To:		From:	
Our Ref:	G36551M-01A	Date:	Thursday, 21 May 2026
<b>65 Quarry Road, Lilydale – Proposed Warehouse Development</b>

Further to your request, we have undertaken a review of the responses received in relation to the proposed warehouse development at 65 Quarry Road, Lilydale and provide the following additional information in relation to the items raised by the community, Yarra Ranges Council and Department of Transport and Planning (DTP).

Figure 1: Original Traffic Report Traffic Surveys

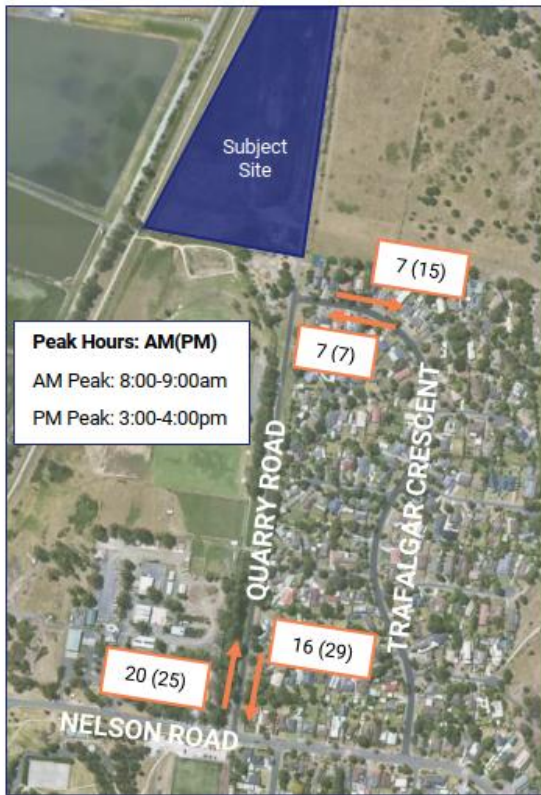
A summary of the traffic surveys, excerpted from the original report, is provided in Figure 1.

In the first instance, these volumes (and the additional information recorded in the original traffic report) shows that Quarry Road currently caters for very limited traffic, with a reasonable proportion of this likely to be associated with the existing residential subdivision accessed from Trafalgar Crescent.

Figure 3: Peak hour and daily traffic volumes at the north end of Quarry Road (27/3/26 – 3/4/26)

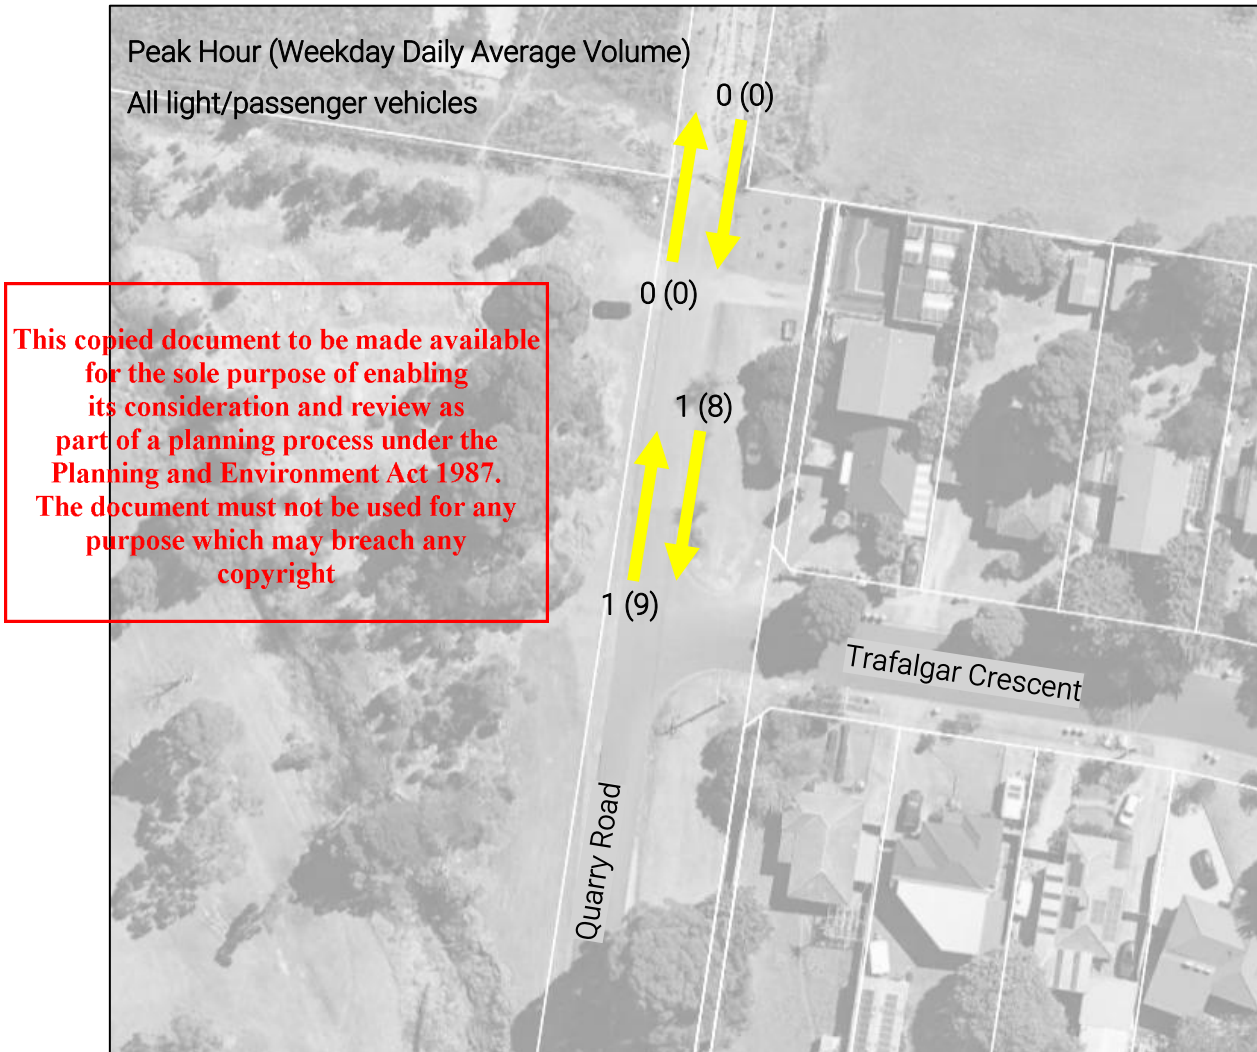
Turning movement counts also recorded if any vehicles passed through the quarry gates  
A summary of the observed traffic movements is shown in Figure 3.

Importantly, a review of the video recordings to verify the tube count data suggests that the vehicles that were recorded a mixture of the following:

- A small number were associated with the dwelling located on the immediate eastern side of the road (and south of the quarry gate). However it should be noted that this dwelling only has legal right of access via Trafalgar Crescent.
- A small number were observed to be associated with vehicles parked to access the Yarra Valley Trail which can be accessed via the grassed area to the north of the oval
- There was a number of movements that were recorded that were observed to be associated with a vehicle driving over the tube count repeatedly (presumably to skew the traffic survey results).
